Re: 300 Binney Street Design Modification

300 Binney Street

CRA Design Review Comments and Responses

Design Review Committee Meeting: October 13, 2022

EXISTING TREES

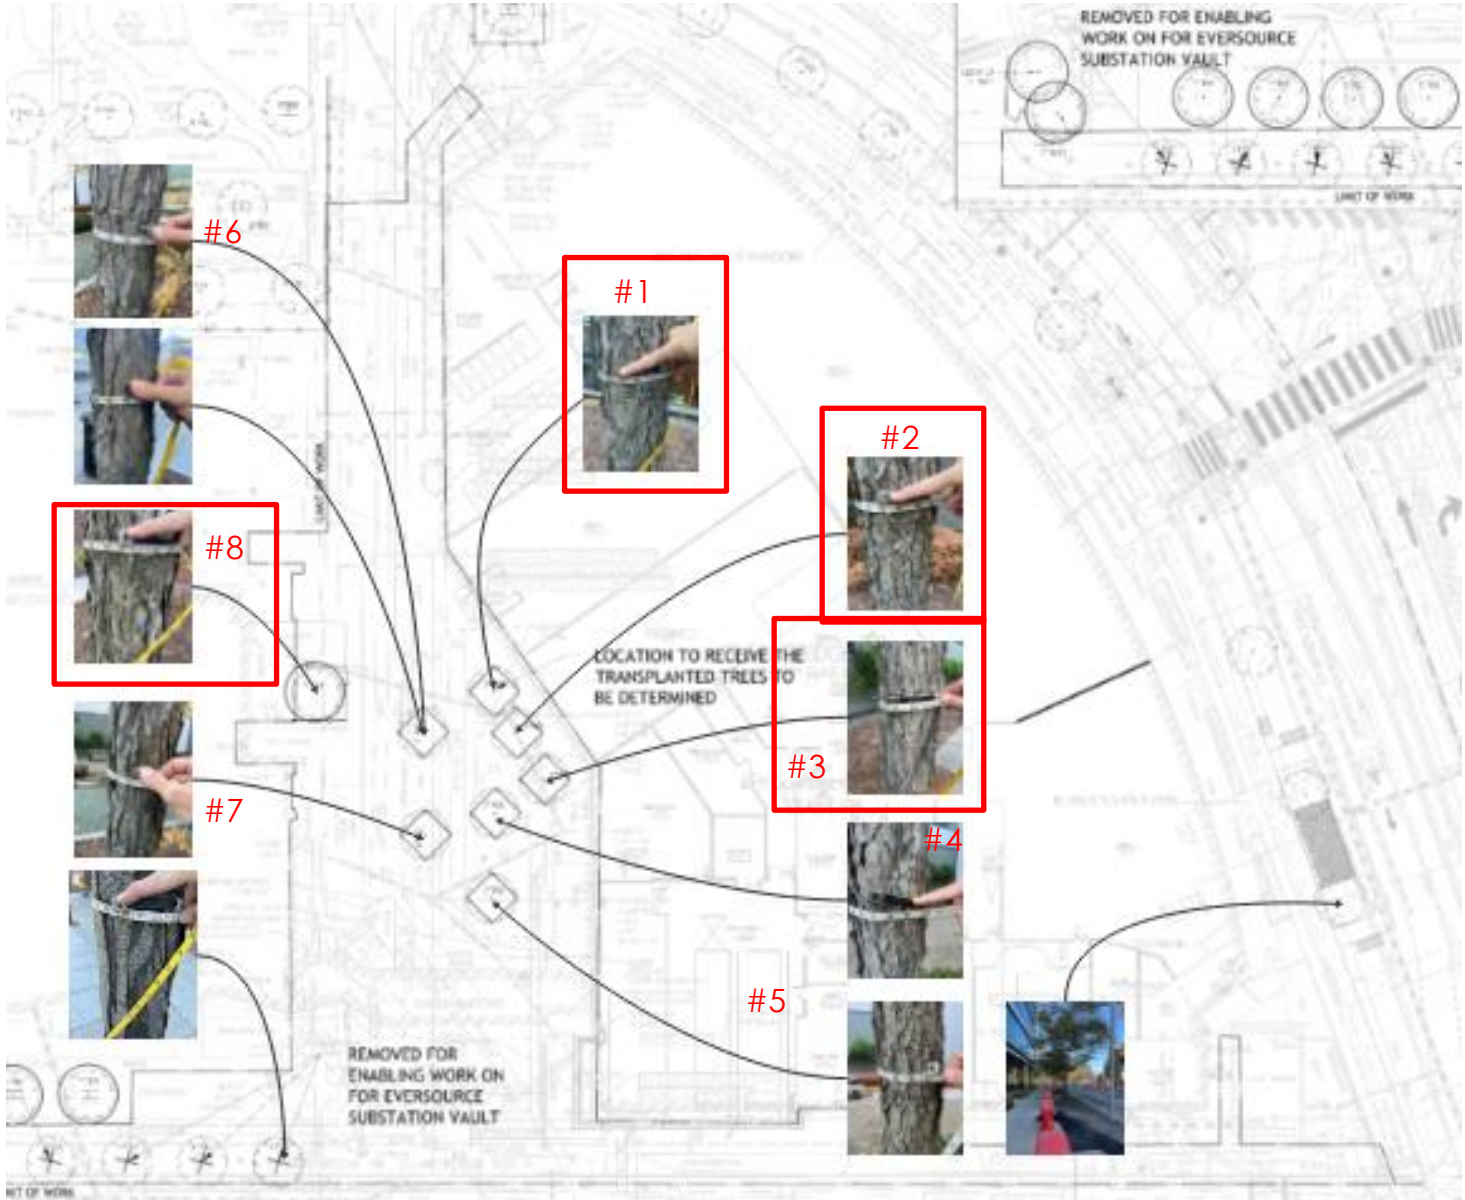
Landscape/Site		
Tree Transplanting Scope	Clarify intent/scope of tree planting and opportunity to transplant - tree inventory	Per a site inspection by Sasaki, the size and conditions of existing trees were verified. An existing and proposed tree inventory and tree mitigation calculation has been included in the CRA Board submission.
Landscape/Hardscape Plan in Context of MXD	More info on adjacent lots/pathways; show 300B scope in context of larger development	The CRA Board re-submission includes a smaller scale landscape context plan.
Bike Parking Quantity/Ratio	Clarify bike parking required counts and provided spaces.	<p>Long Term Spaces: The new secured Bike Room has capacity for 48 bike spaces. Per article 6.100 of the zoning code, the number of required bike spaces is 48 spaces, calculated as follows:</p> <p>Zoning Requirements per Article 6.1 12,000 GFA : Bright Horizons - .3 bike spaces per classroom x 6 classrooms = 2 spaces 176,000 GFA : Broad 60/40 lab/office split 105,600 (60% lab) - N2 (technical office / research facility) .22 per 1000 sqft = 24 spaces 70,400 (40% office) - N1 (office) .3 per 1000 sqft = 22 spaces TOTAL required = 48</p> <p>Short Term Spaces: We currently show 12 new bike spaces at the front entrance to the lab/office space near Binney Street and 12 new bike spaces near the entrance to Bright Horizons. Per article 6.1 of the zoning code we believe the project requires 11 spaces for the day care use and 11 spaces for the lab/office use. See below:</p> <p>Zoning Requirements per Article 6.1 12,000 GFA: Bright Horizons - 1.7 bike spaces per classroom x 6 classrooms = 11 spaces 176,000 GFA: Broad 60/40 lab/office split 105,600 (60% lab) - N5 (laboratories and research facilities) 0.06 per 1000 sqft = 6.3 70,400 (40% office) - N5 (professional and technical offices) 0.06 per 1000 sqft = 4.2 TOTAL required = 22</p>

EXISTING VS PROPOSED MASSING OF PENTHOUSE
LOWER SCREEN HEIGHTS

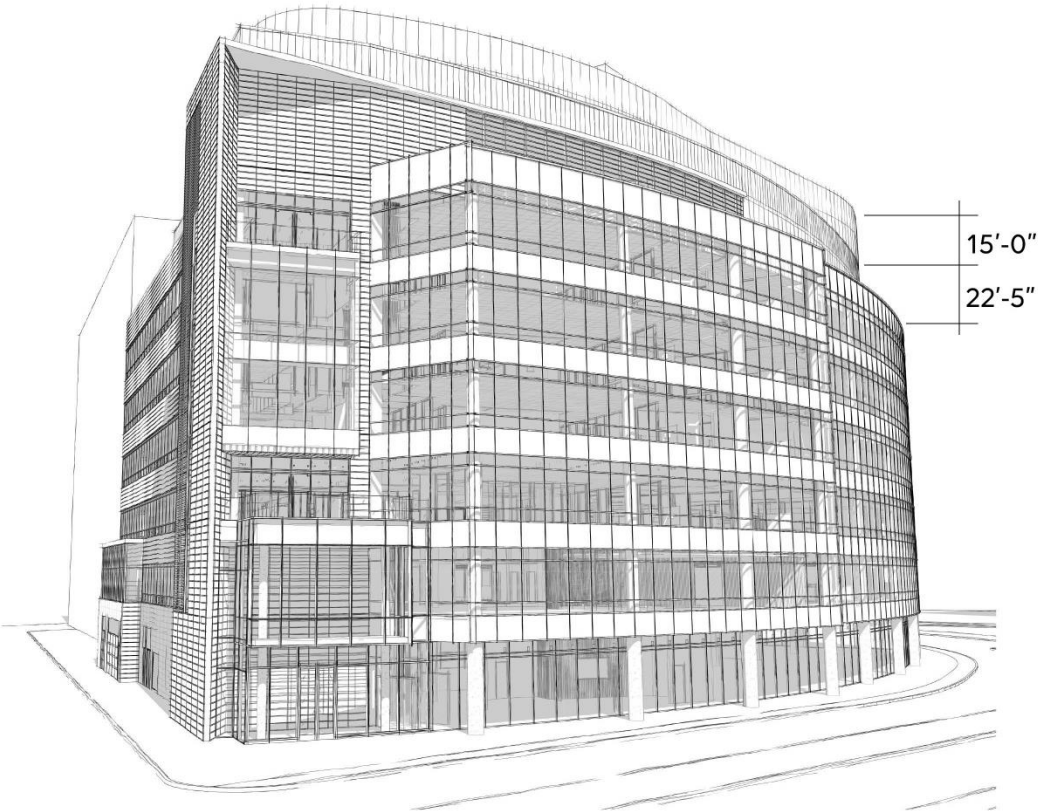
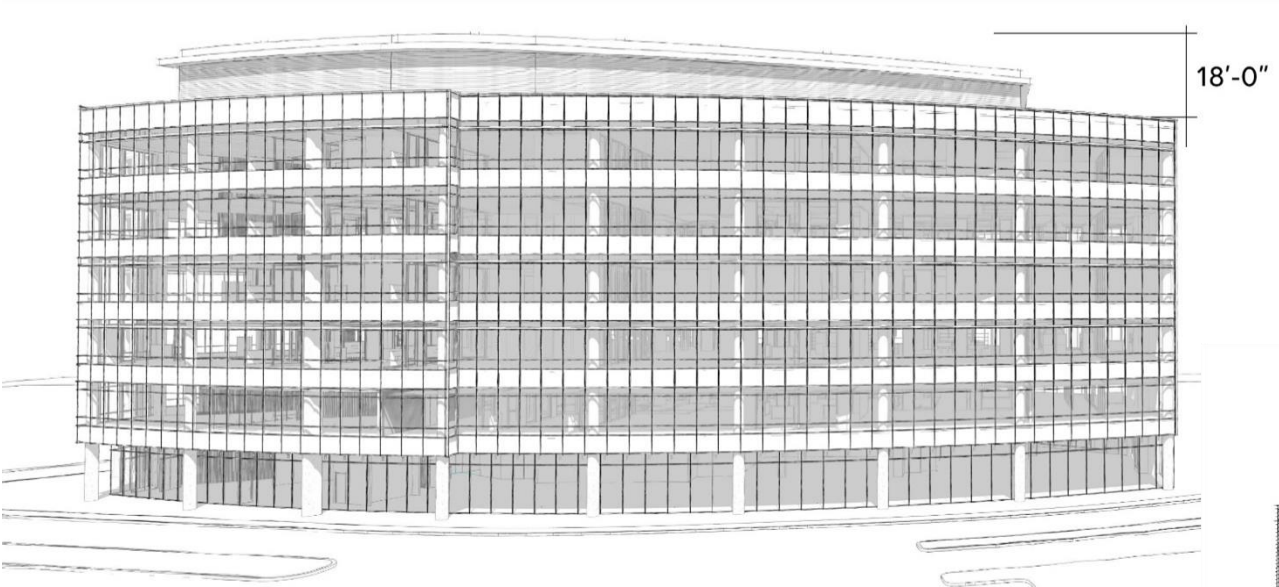
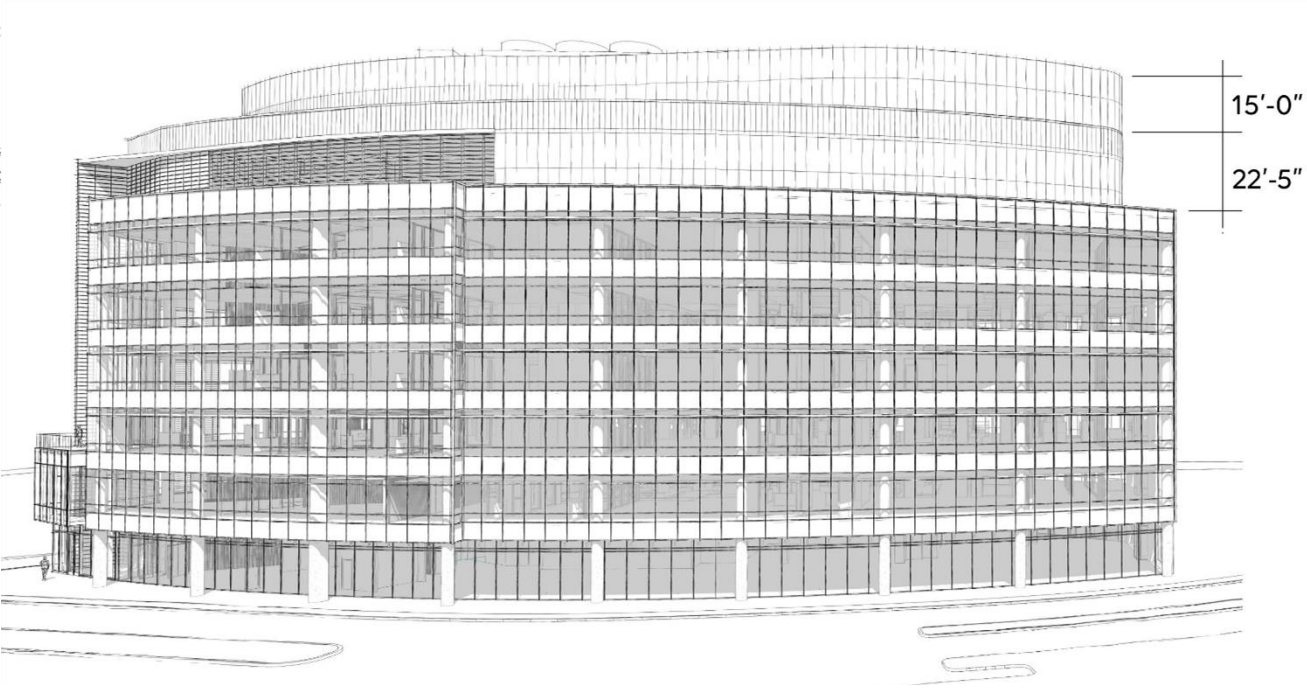
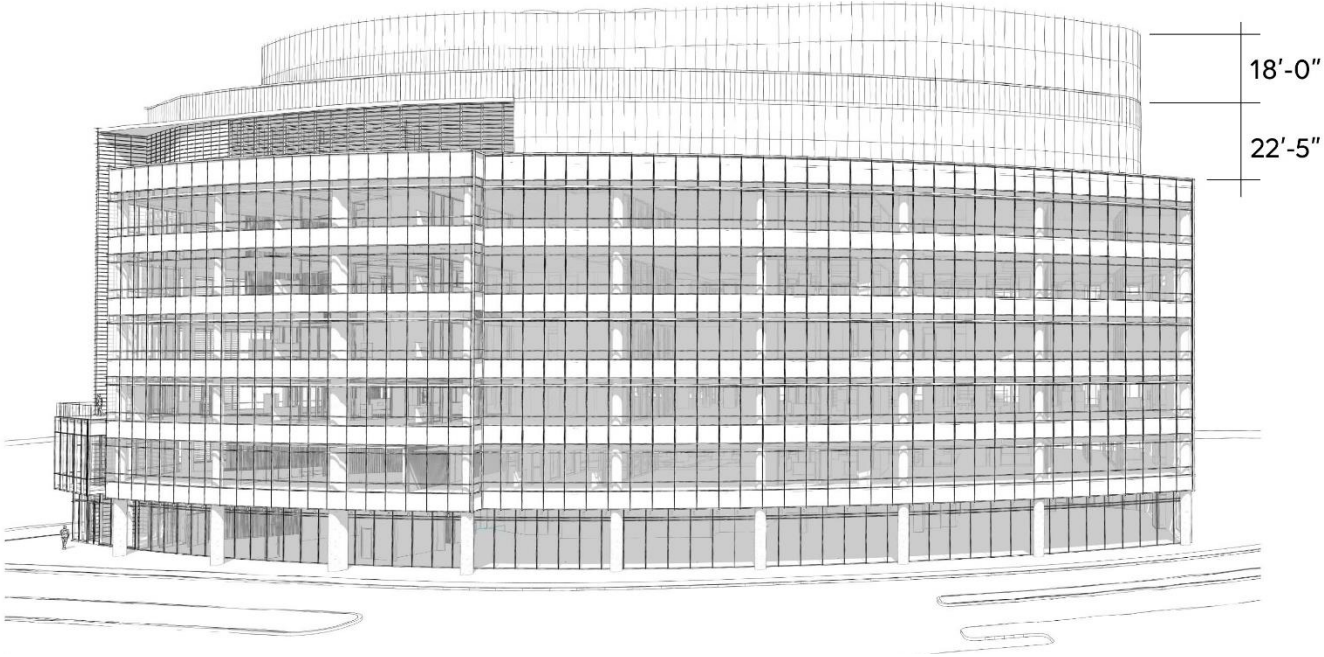
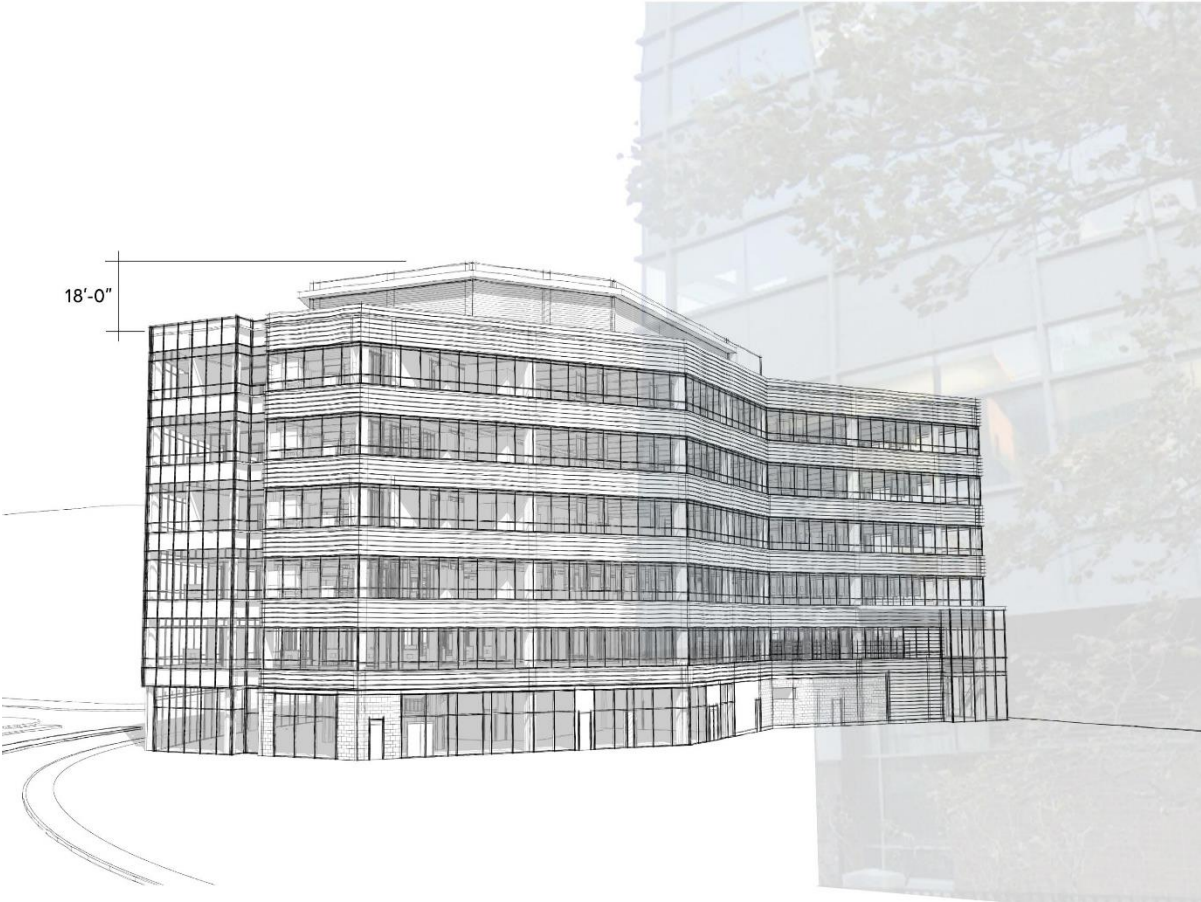
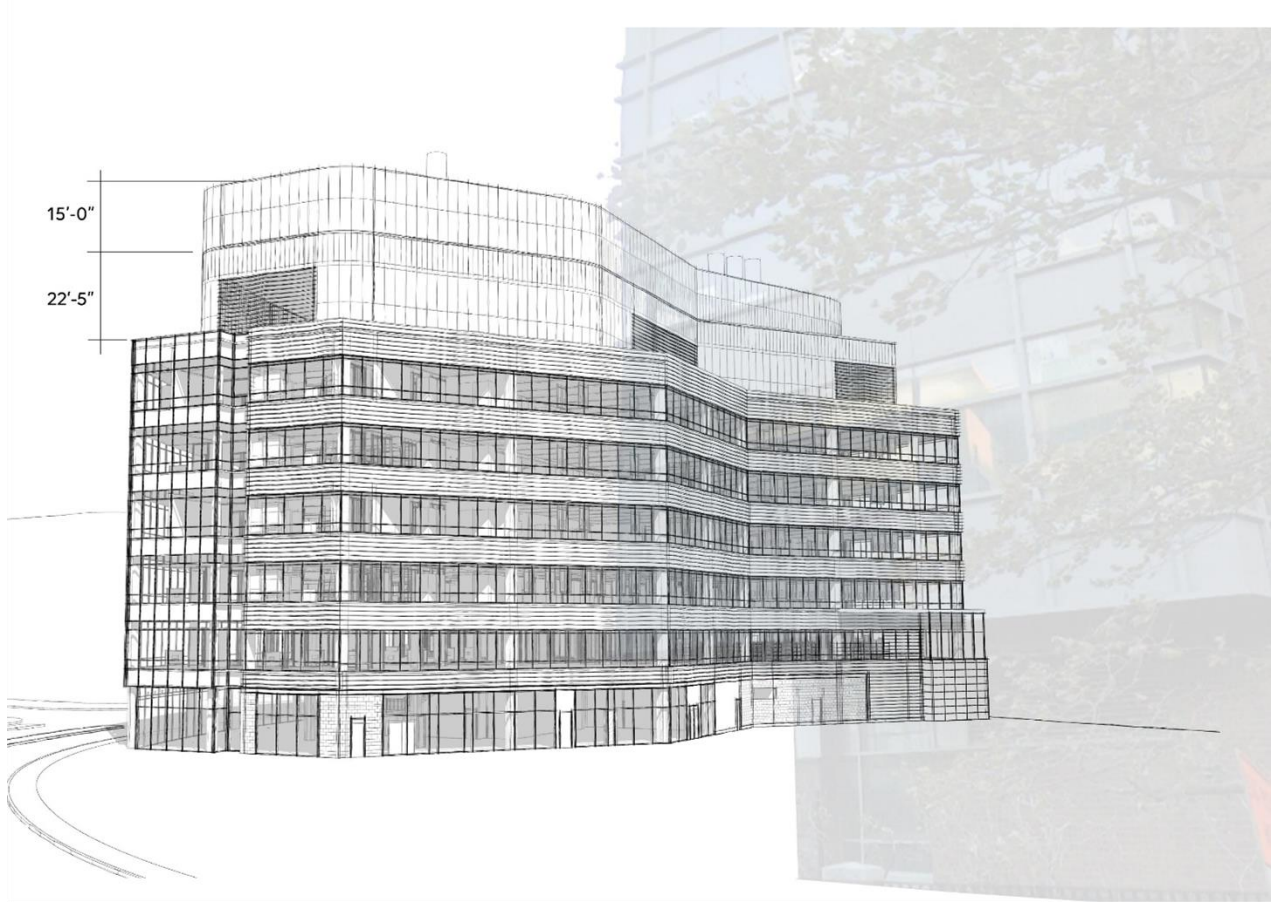
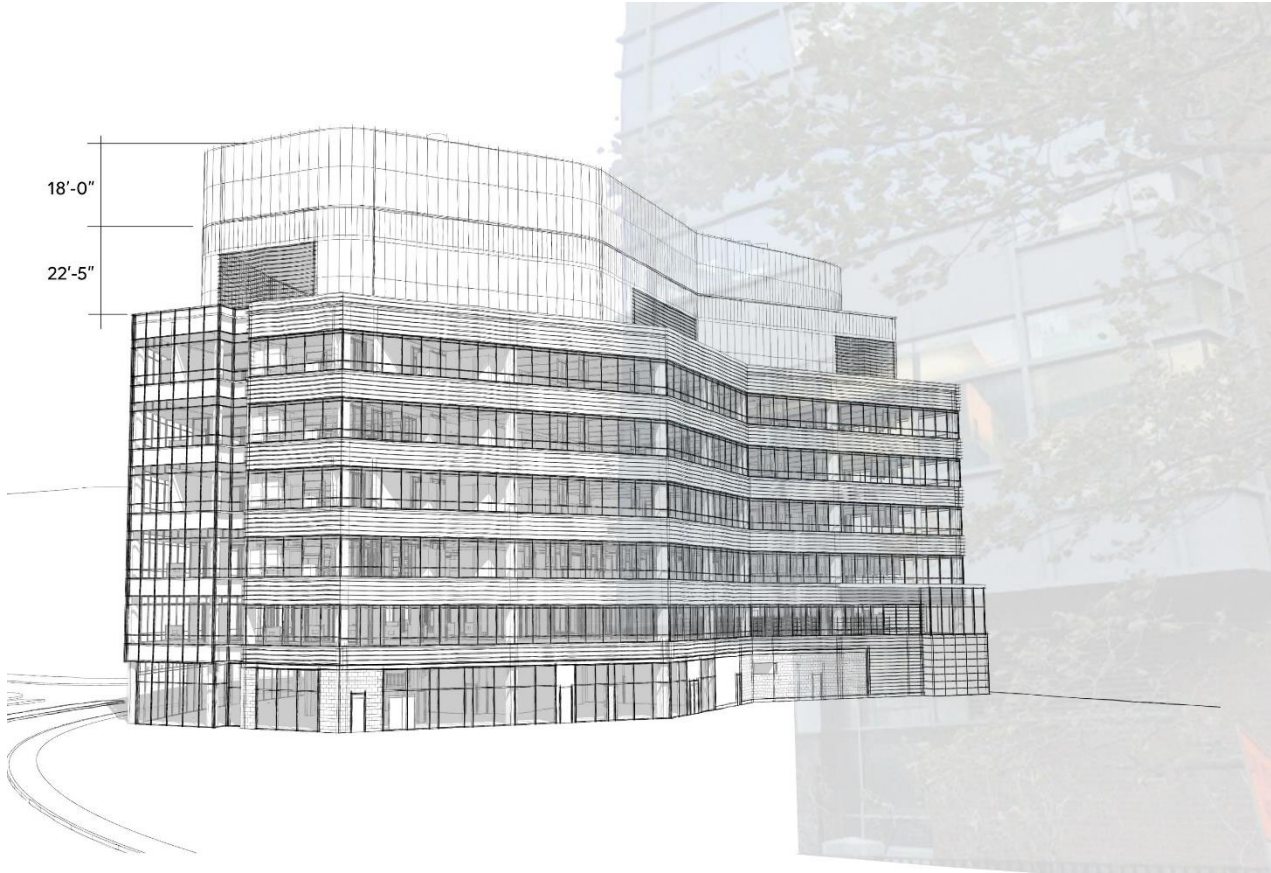
Category	Comment	Response
Exterior Improvements		
Penthouse Massing	Show the existing vs. proposed massing of penthouse together. The currently shown height of the screen wall is 20'. Study different heights of the proposed screen wall. Goal would be to obscure mech equipment case, no need to obscure stacks	The CRA Board Submission includes perspective views with screen wall heights at 20', 18' and 15'; we are finalizing specific mechanical equipment, exhaust stacks and generator flues and how each may or may not be visible in the perspective views provided. Final presentation materials for these views will be finalized for the Board presentation on Nov 16th
Shadow Study	Compare to existing building and 290 shadow. Confirm highest piece of equipment	The CRA Board Submission includes Shadow Studies. The base modeling assumes a 20' screen wall and hence is conservative if screen wall is reduced. The Dec shadow study includes a representation of reduced views with screen wall at 18' and 15' heights.

300 BINNEY PROPOSED NORTHEAST CORNER- PREFERRED

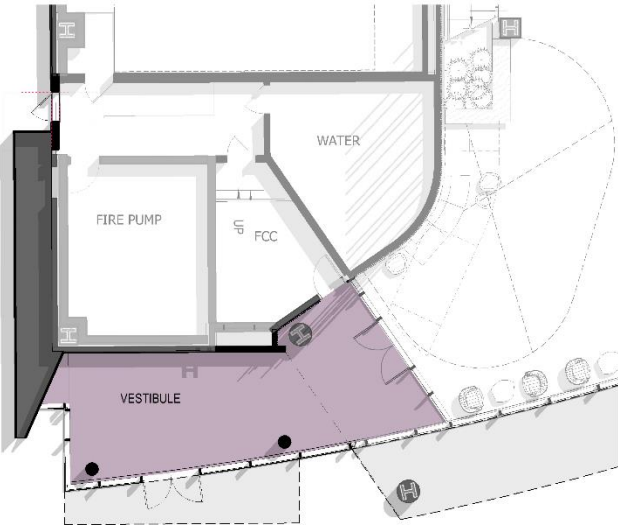
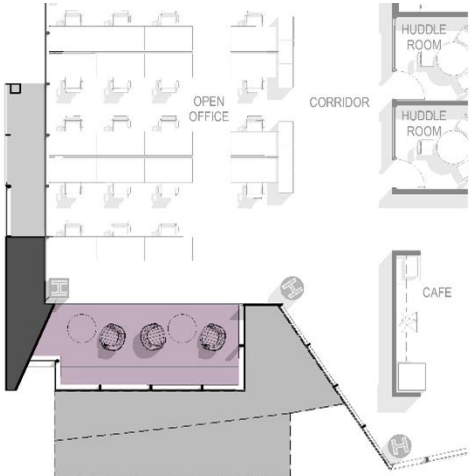
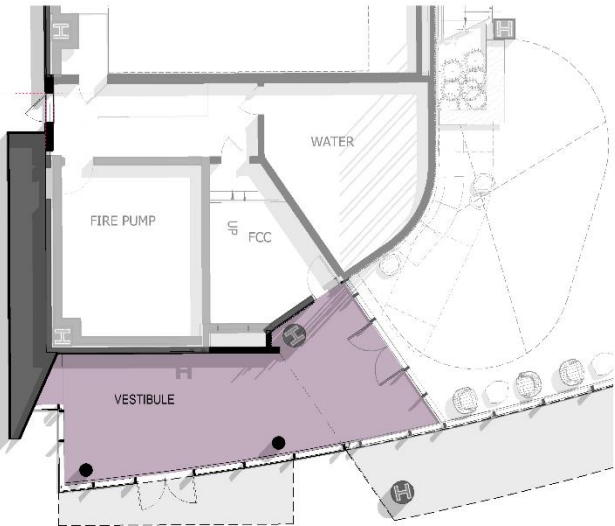
Glass Bay Window	Describe the relationship between the upper level glass boxes added and the adjacent wall on the east side	The CRA Board Submission includes further detail on the glass bump out and an alternative studied that pulls out the glass from the east wall.
Exterior Lighting/	Describe exterior lighting strategy; minimize light pollution from NE corner and potential signage No large scale signage intended by Broad, lighting will be accent rather than beacon. Additional studies will be developed.	Lighting of the new lobby and vestibule will be primarily interior lit Exterior lighting will be limited and designed to minimize any light spill Signage is generally planned as follows (a separate signage submission will be made at a future date): ** an exterior building sign ** signage at main lobby entrance ** signage within the main lobby
Exterior Wall at South	Study wall between Bright Horizons and Loading Dock - even if blank/utilitarian, consider surface treatment Action: Design of surface treatment will be studied.	The CRA Board Submission includes an enlarged South Elevation showing improvements to this façade to account for new daycare entrance and other associated program elements
